Introduction

This errata sheet provides updated information on Cyclone® devices. This document addresses known issues and includes methods to work around the issues.

Figure 2. JTAG Configuration of Single Cyclone FPGA

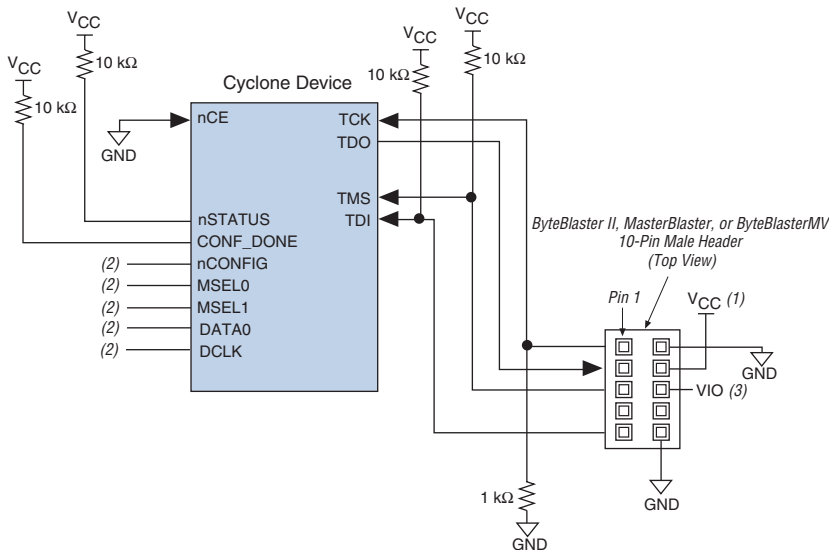
Altera has identified a documentation issue in two separate figures:

- Figure 13-19, *Cyclone Device Handbook* ver 1.5 (Chapter 13. Configuring Cyclone FPGAs)
- Figure 5-19, *Configuration Handbook* ver 1.5 (Chapter 5. Configuring Cyclone FPGAs)

Both figures show an external pull-down resistor to GND on the TCK signal of the JTAG interface. **Figure 2** below shows the correct resistor value of “1kΩ” instead of “10kΩ”.

Cyclone FPGAs have an internal weak pull-up resistance on TCK in the range of 15k Ω to 50k Ω . An external pull-down resistor value of 1k Ω ensures that a valid low-level signal is present on TCK when left un-driven, regardless of the actual value of the internal weak pull-up resistance.
